**APPEAL (LAND-2018-00794)  
DENIAL OF DEVIATION REQUEST (DEVREQ-2018-00530)  
PLANNING DEPARTMENT REPORT TO HEARING EXAMINER**

SUBJECT: JOHN DEVORE’S APPEAL OF A DEVIATION REQUEST THAT DENIED A REQUEST FOR RECONSIDERATION TO ALLOW A SECOND DRIVEWAY DEVIATION REQUEST (DEVREQ-2018-00530).

DEVREQ-2018-00530

**SITE PLAN**  
SCALE: 1" = 30.00'

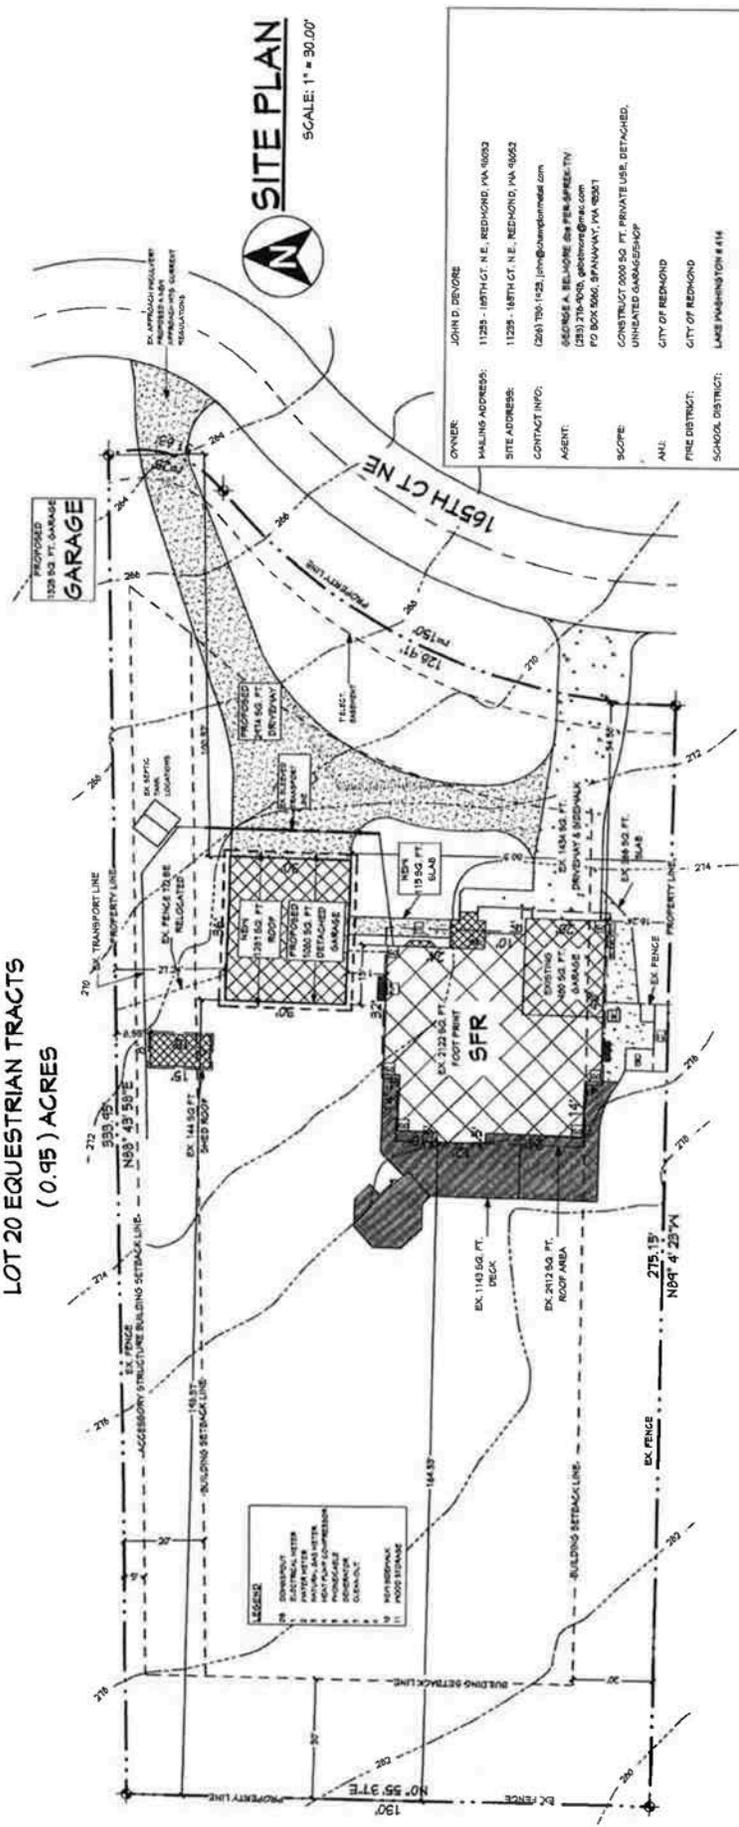
The appellant is proposing a second residential driveway location at an irregular three-leg uncontrolled intersection located at the intersection of Northeast 113<sup>th</sup> Street and 165<sup>th</sup> Court Northeast. The site plan provided by applicant fails to identify the intersection street which is located directly at the proposed second driveway. The appellant's property is located within a 38-lot single-family subdivision, which has only one access point via Northeast 113<sup>th</sup> Street (a private street) to Northeast 116<sup>th</sup> Street, which is a public road (Exhibit 8: Location Map). City staff has provided the City of Redmond (COR) Administrative Engineering Deviation Procedure document (Exhibit 9: City of Redmond Procedures for Deviation Requests) to the appellant at the counter when the appellant inquired about the building permit application. From the appellant's initial deviation request (Exhibit 1: Appellant's initial deviation request, dated April 30, 2018), the appellant fails to address the criteria for granting engineering deviations as outlined in Section 2 of the COR's Administrative Engineering Deviation Procedure (Exhibit 9, City of Redmond Procedures for Deviation Requests). The Deviation Review Team studied the site location along with the aerial imagery for analysis of the 2<sup>nd</sup> criteria out of seven criteria related to safety. Based on the aerial imagery with property line information and the location of the proposed 2<sup>nd</sup> driveway (Exhibit 8, Location Map), the Deviation Review Team is concerned that the proposed 2<sup>nd</sup> driveway location will create unsafe situations due to the (1) existing vegetation from the adjacent north neighbor and will block the driver sightlines, (2) location at the irregular three-leg uncontrolled intersection, and (3) confusing traffic patterns that would

result. Since this property has an existing driveway with the option to design the oversized vehicle maneuver around onsite, it will be a safer approach instead of allowing the 2<sup>nd</sup> driveway to be installed for safety reason. Staff further confirmed that “driveways” as discussed in RZC Appendix 2.D (“*Driveways, as used in this appendix, shall refer to vehicle entrances to individual lots and the intersection of access corridors with public streets.*”) is not only intended for public streets, but also includes private streets.
